LC-19531

TENNESSEE VALLEY AUTHORITY
DIVISION OF POWER ENGINEERING AND CONSTRUCTION
HARRIMAN, TENN. SUBSTATION-69KV
CONDUIT AND LIGHTING
PLAN AND DETAILS

TENNESSEE VALLEY AUTHORITY DIVISION OF POWER ENGINEERING AND CONSTRUCTION			
HARRIMAN, TENN. SUBSTATION-69KV CONDUIT AND LIGHTING PLAN AND DETAILS			
DATE: 4-2-47	DESIGNED BY: J. M. Dutton	APPROVED: K. E. Hays	SHEET 1 OF 4 SHEETS
SCALE: 1/4" = 1'-0"	CJOI	LC-19531

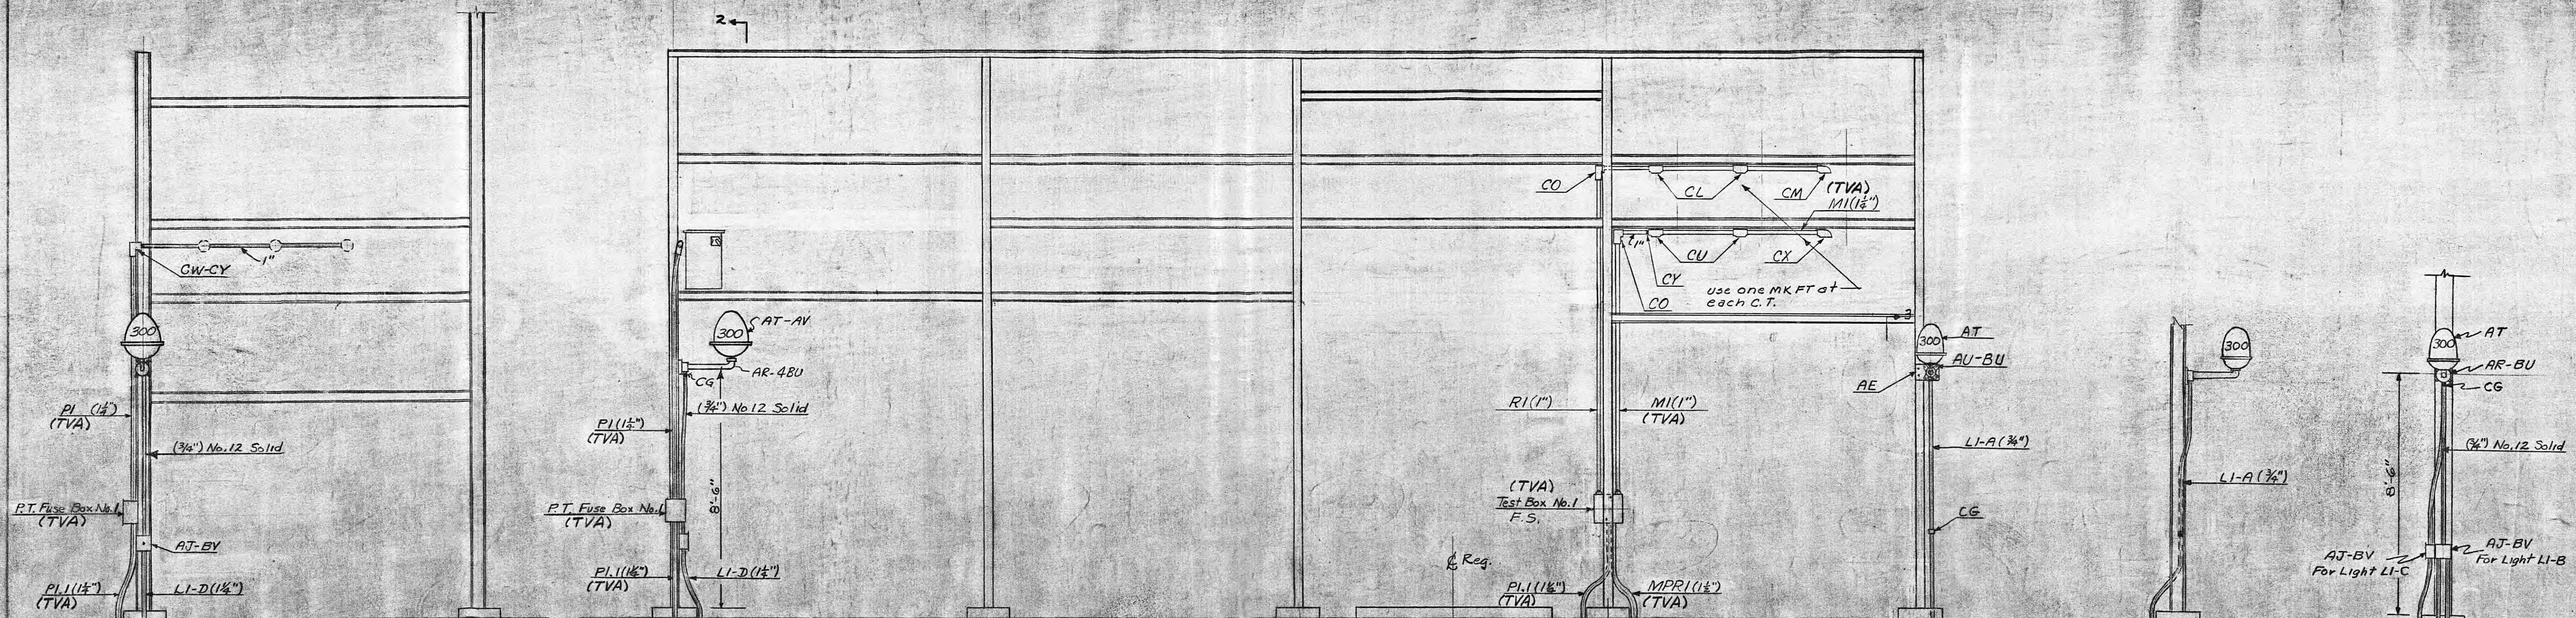
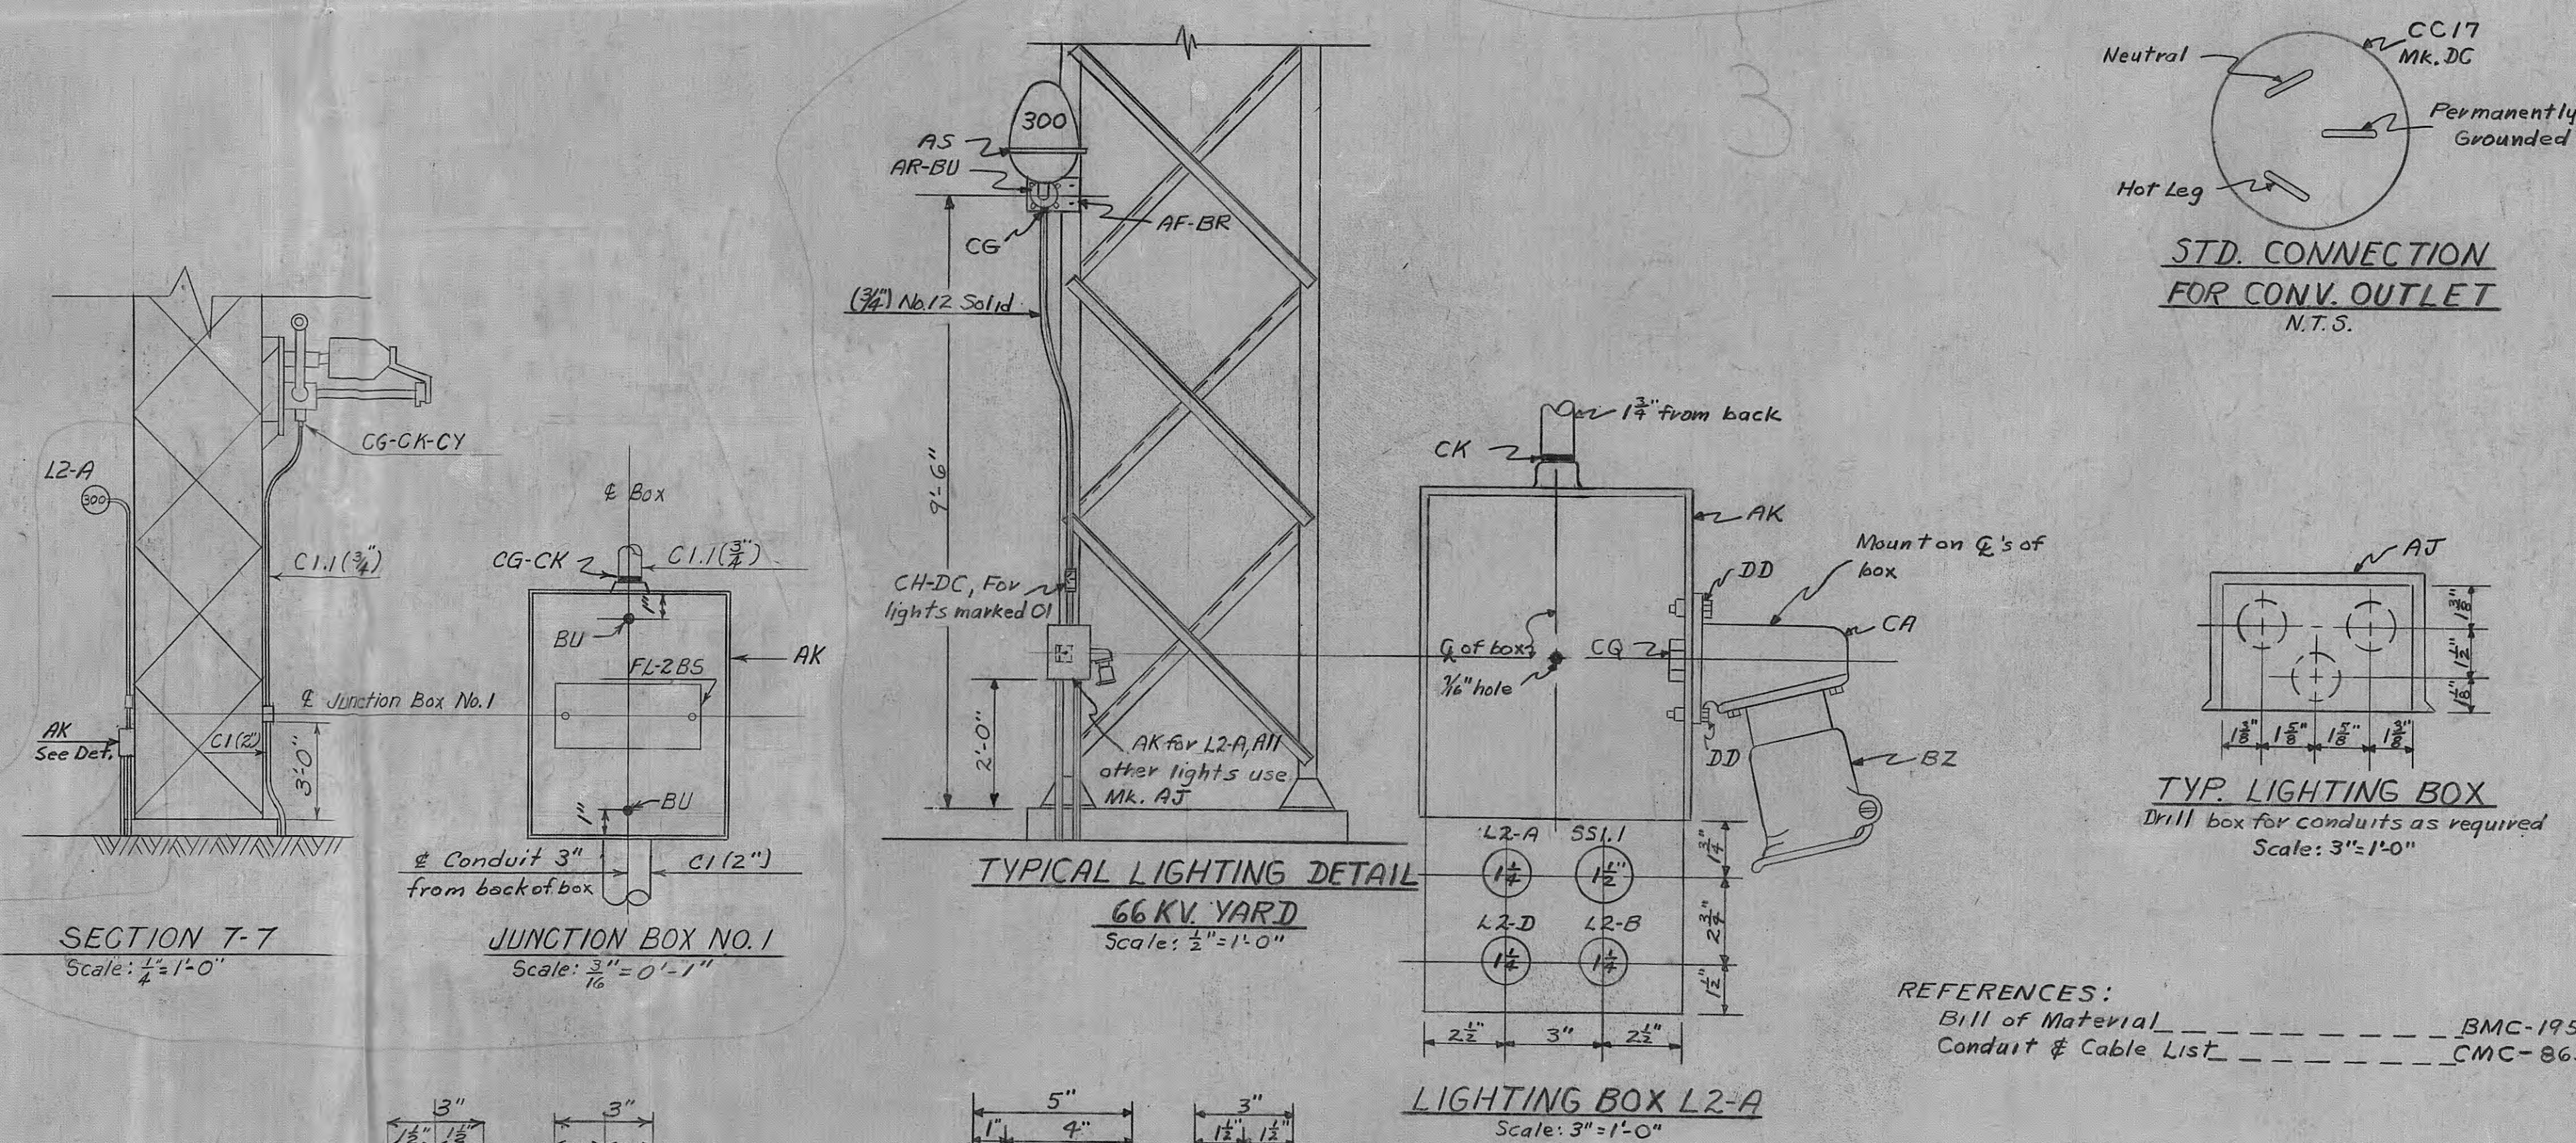
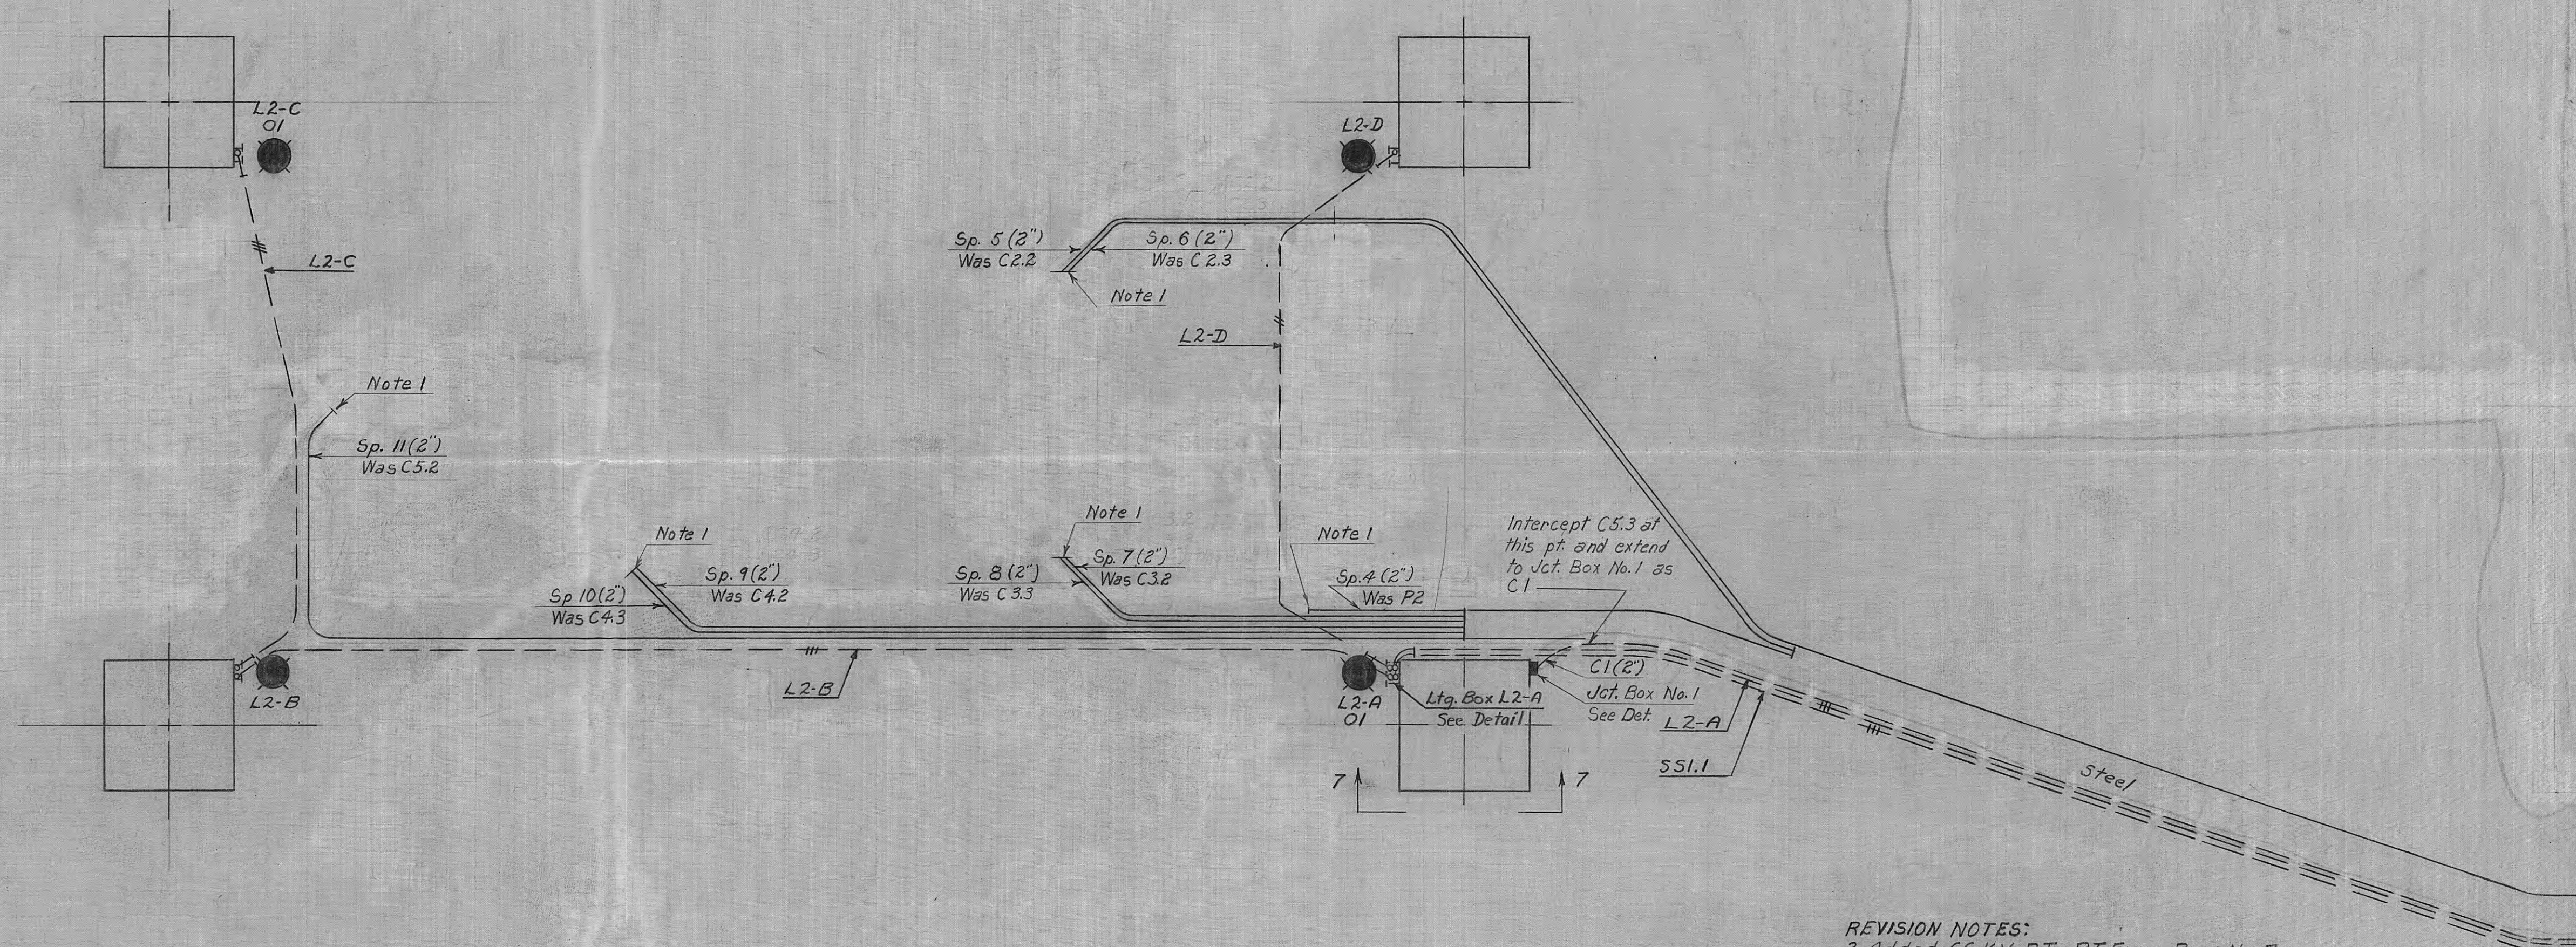
REVISION NOTES:
3. Added 66 K.V. P.T., P.T. Fuse Box No. 7, P7.1
5. Removed: Fuse Box No. 2, No. 3, No. 4, No. 5, No. 7;
Conduit and Cables, P3.1, R1, C2, C2.1, P2.1, P2.3, P2.2, P2.2,
P2.3, P2.4, R2, C3, C3.1, P7.1, R3, C4, C4.1, P4.1, P5.1, R4, C5, C5.1
Cables, C2.2, C2.3, P2, C3.2, C3.3, C5.2, C5.3, C4.2, C4.3
Added: Jct. Box No. 1, C1.

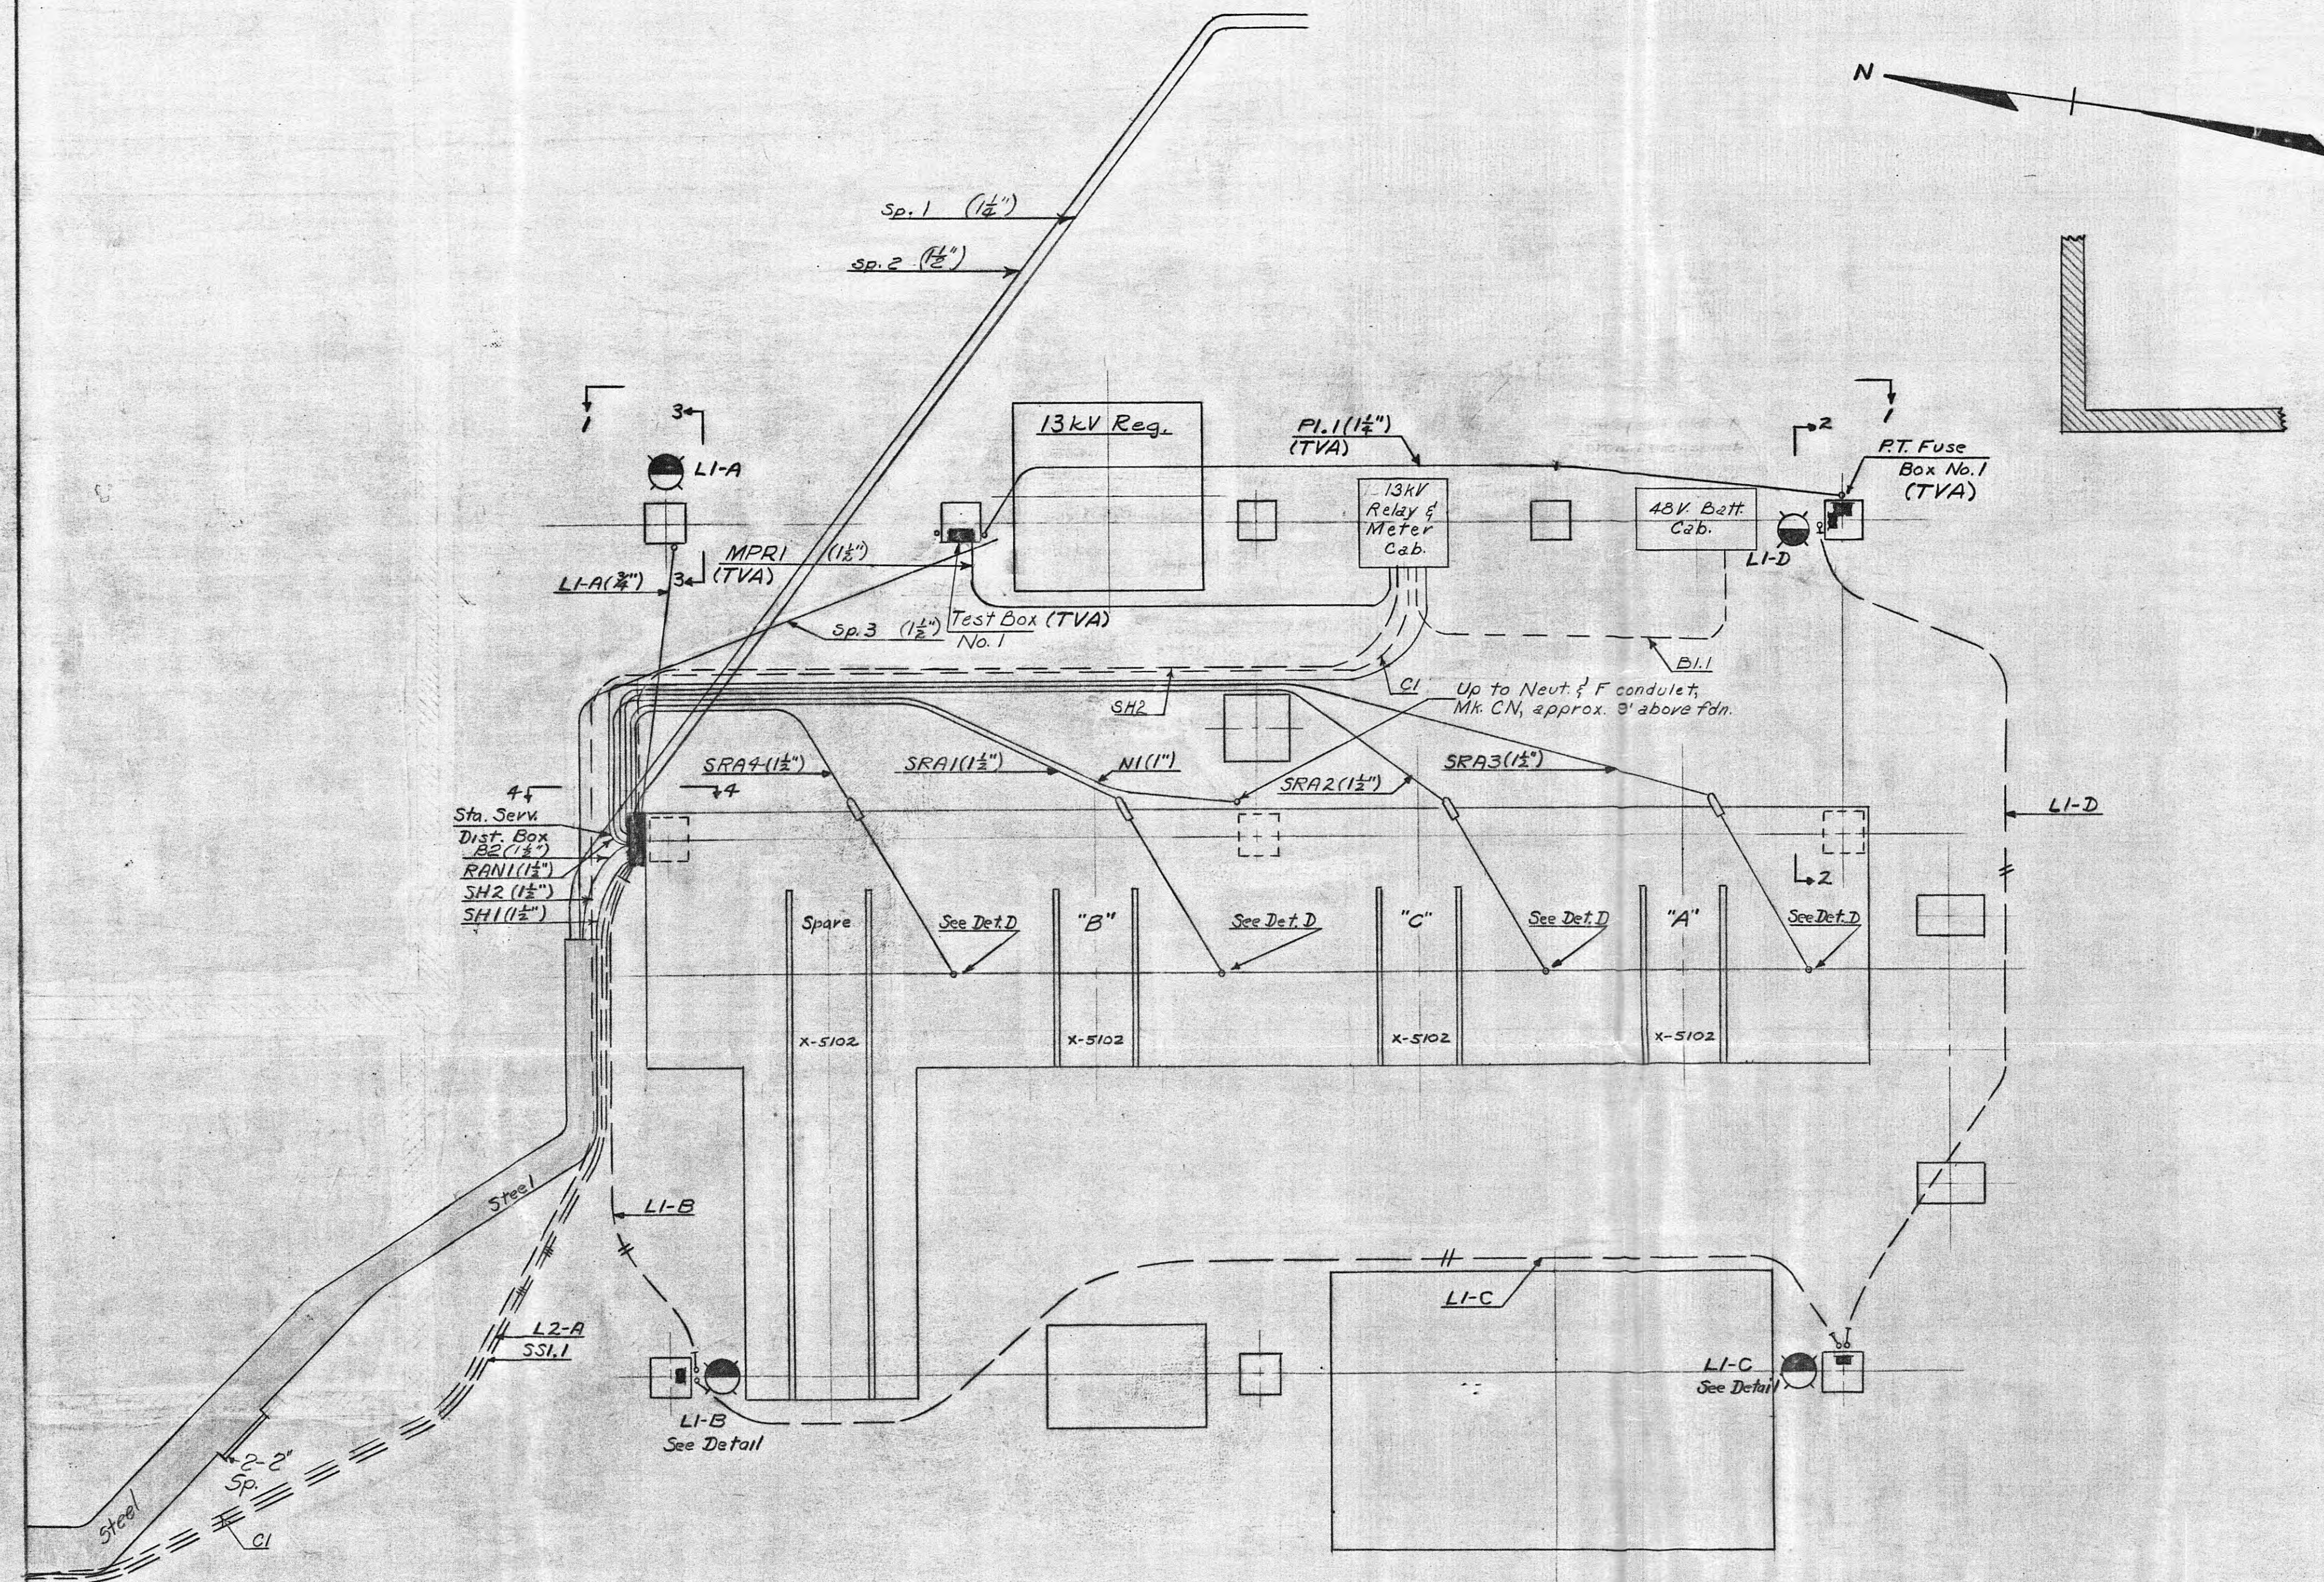
Revision Notes:
3. Redrawn:
Relocated: PI.1 was part of old PI
Removed cable & abandoned conduit: old(R2), SENI.2, IOMI, SBI
Added: MPI, CI, SRA1, SRA2, SRA3, SRA4, NI, RAN1, SH1, SH2, SSI.1, L2-A
Tagged: PT Fuse Box No.1
Retagged: Test Box No.1 was Test Sw.Box No.1
Removed: old light units(LI-B, LI-C, LI-D), Battery Cab., & old OCB No. 204 (2" LB conduit between mech. and cabinet to stay in place on OCB)
Added: new light units(LI-B, LI-C, LI-D)
